Commonwealth Edison

Subject: Braidwood Station Units 1 and 2
Additional FSAR Information
NRC Docket Nos. 50-456/457

The Attachment to this letter provides our response to Questions 241.1, 241.2, 241.7, and a revision to 241.6-3. Our FSAR will be amended to include the information contained in the Attachment to this letter as appropriate. Additionally, in supplement to Question 361.5 Part (a), photographs with identifiable sections of the excavations of the main power block have been sent directly to Ms. Janice A. Stevens as listed in the Attachment.

FIGURE Q241.2-1
GRAIN SIZE ENVELOPE, SAND
BACKFILL, ESWP WITHIN ESCP

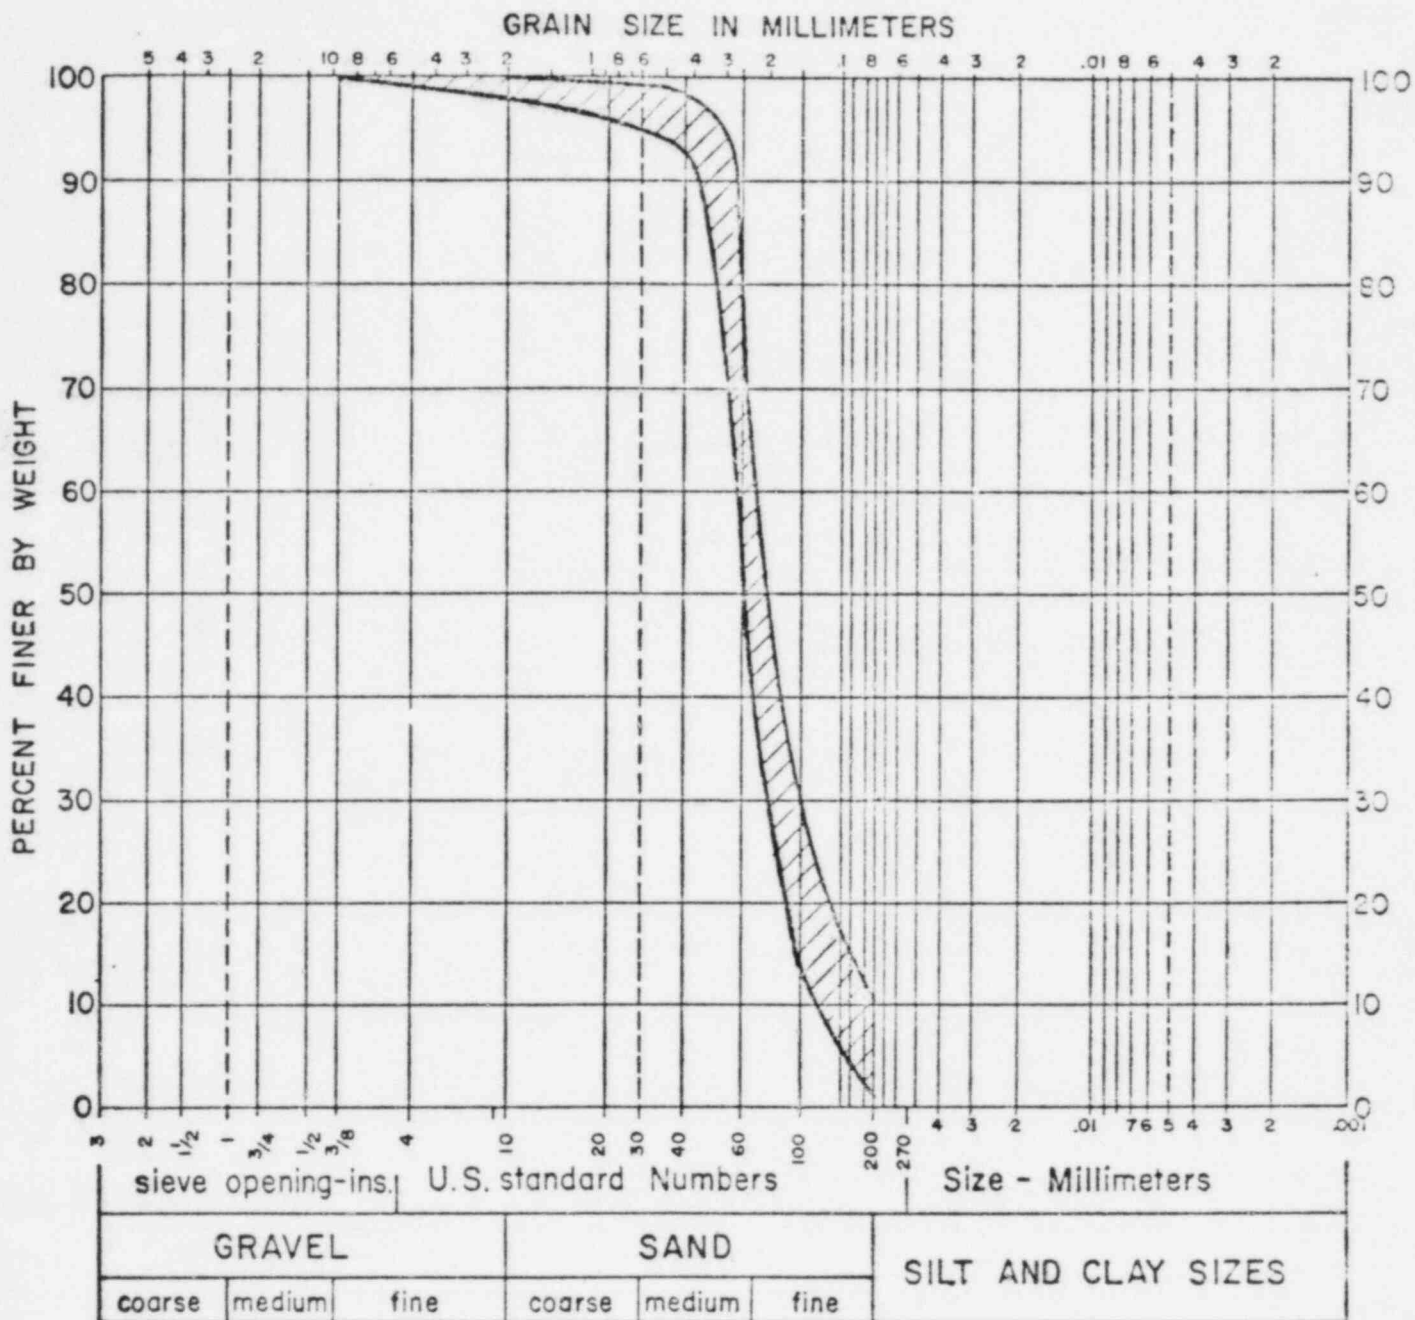
"Provide information on the gradation, method of compaction, placement density, and moisture content specified for the granular backfill used beneath and surrounding all Category I structures and buried pipes. Furnish plots presenting results of the quality control field tests performed to verify that the actual construction is in compliance with the specifications."

Category I granular backfill for the main plant and essential service cooling water pipelines has been discussed in detail in Subsections 2.5.4.5.2.2 and 2.5.4.5.4.2, respectively. Project specifications specified that the backfill material be approved material from previous excavations or borrow areas onsite. The sand backfill used was approved. Figures 2.5-261 and 2.5-262 give an envelope of 58 grain size curves for the granular backfill used in the main plant area and three grain size curves for the granular backfill used in the essential service water pipeline trench also in the main plant area. Figure Q241.2-1 gives an envelope of 12 grain size curves for essential service water pipeline backfill within the essential service water cooling pond.

FIGURE Q241.7-1
 CRITICAL SECTION FOR
 STATIC ESCP SLOPE
 STABILITY ANALYSIS

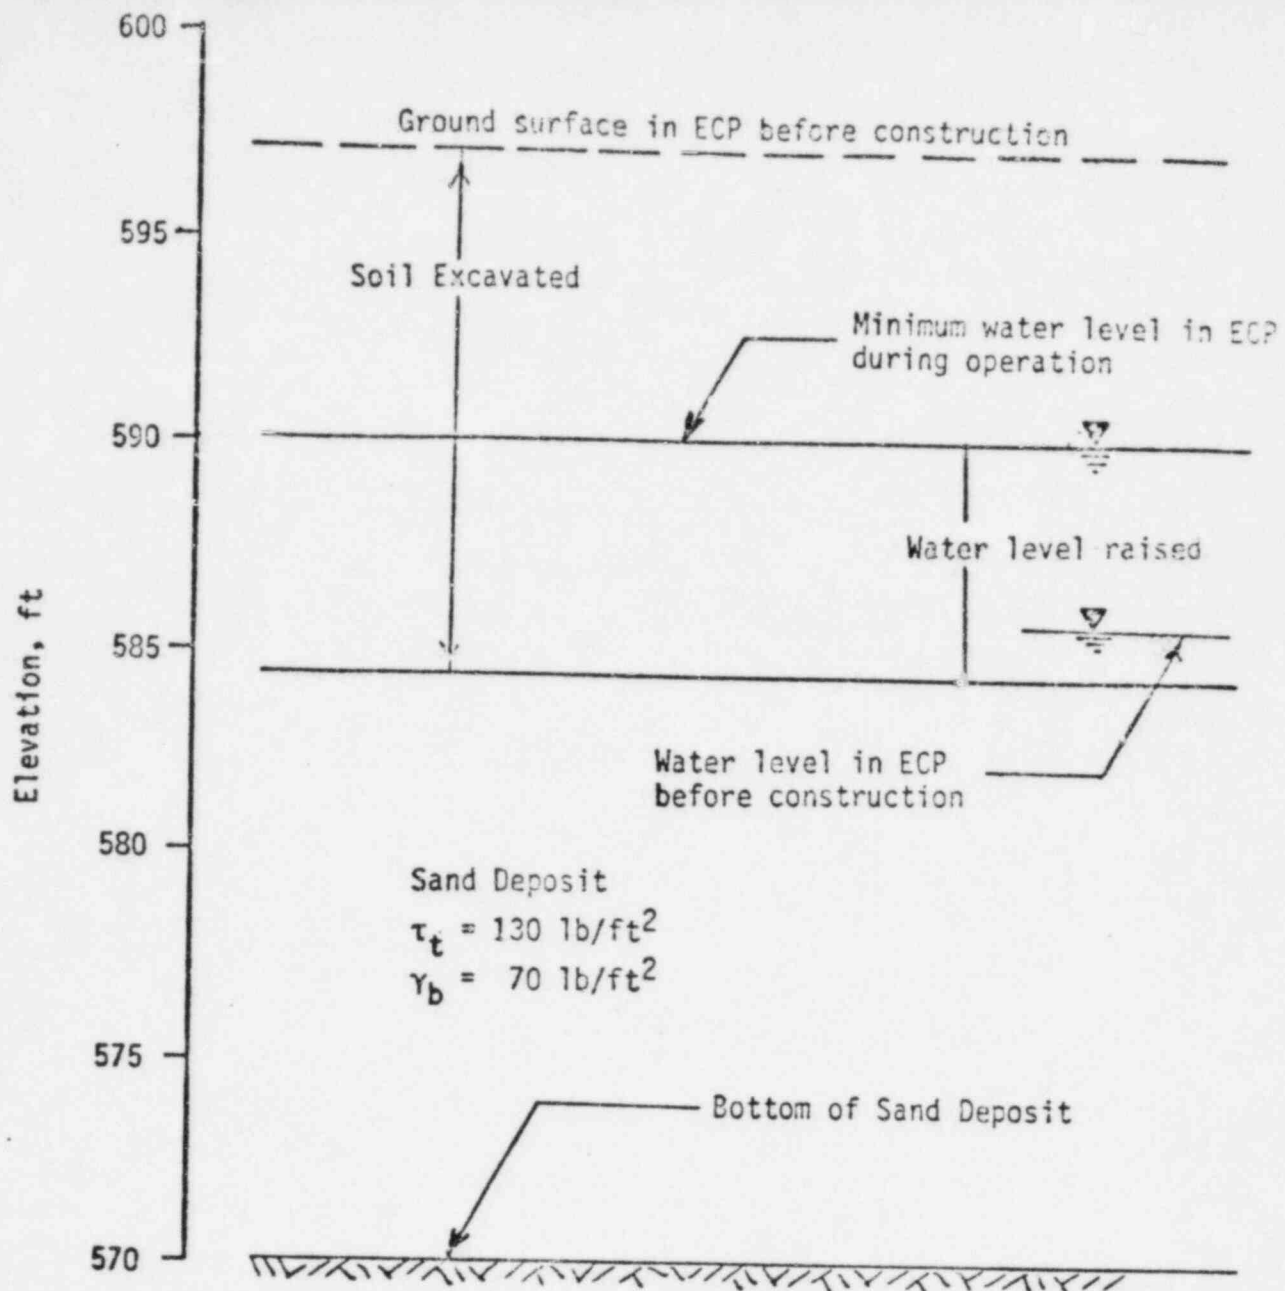
- "1. Present a figure showing the critical section of the ESCP slope analyzed for static stability. Show the critical failure surface and the corresponding factor of safety against failure.

1. The critical section of the ESCP slope analyzed for static stability is given in Figure Q241.7-1. The analysis is for end of construction condition with a minimum factor of safety of 5.9 as discussed in Subsection 2.5.6.5.1.2.
2. The seismic coefficient used in evaluating the dynamic stability of the ESCP slope by pseudostatic method of analysis was 0.2g. The minimum factor of safety is 1.3 as discussed in Subsection 2.5.6.5.1.2. The ESCP slope has also been analyzed with a seismic coefficient of 0.26g and the minimum factor of safety is 1.1.
3. The dynamic stability of the ESCP slope by finite element methods was not performed because the pseudostatic analysis used yields conservative results and a greater minimum

BRAIDWOOD STATION
FINAL SAFETY ANALYSIS REPORT
FIGURE Q 241.7-3
EVALUATION OF LIQUEFACTION
POTENTIAL - LEVEL GROUND AT
E1 584 FT - C_r BASED ON D_r

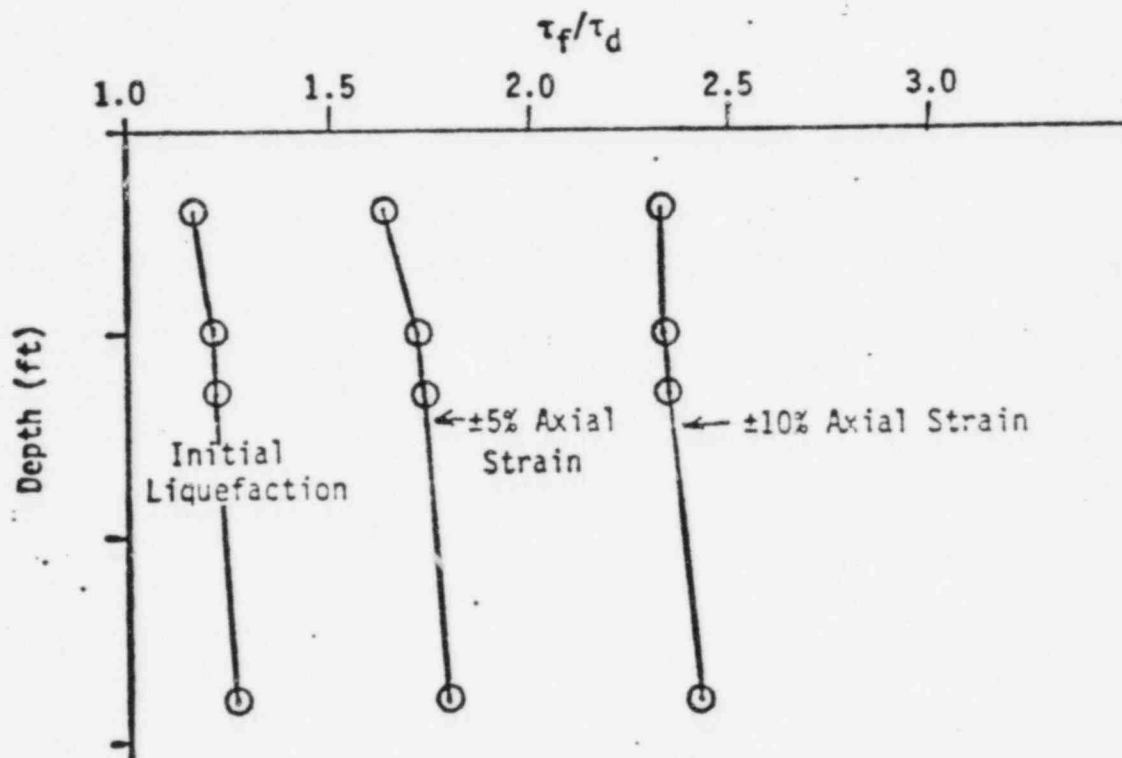
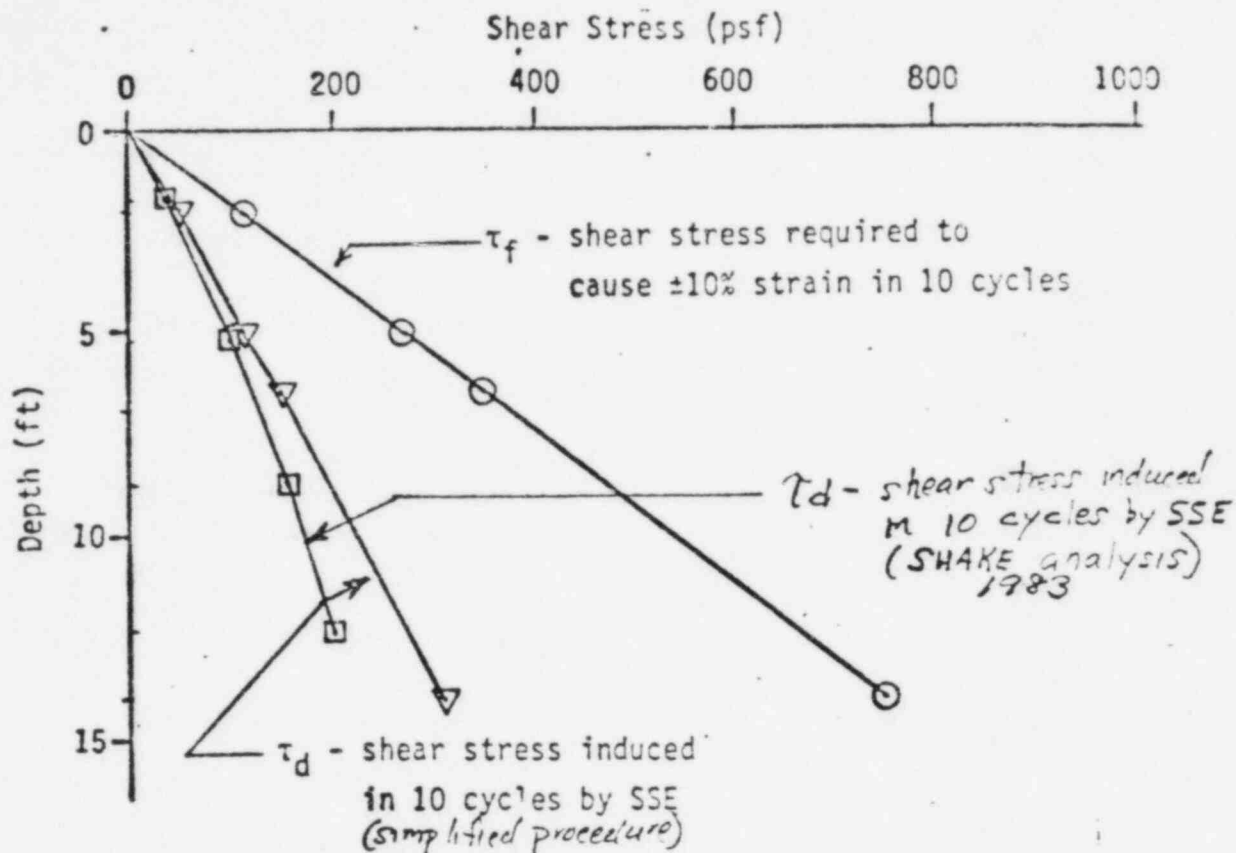
- "3. Evaluate the dynamic stability of the ESCP slope.
- "4. The liquefaction study using the SHAKE program evaluated the case with the level ground at elevation 590.0 ft. Provide the results of a similar study for the ESCP bottom, at elevation 584.0 feet.

The induced stresses, (τ_d), and the stresses required to cause +10% strain (τ_f) for level ground at elevation 590 feet are compared in Figures 2.5-116 and 2.5-117, and for level ground at elevation 584 feet in Figures Q241.7-3 and Q241.7-4. Figures Q241.7-3 and Q241.7-4 are plots of data from Table Q241.7-3 which correspond to average relative density conditions.
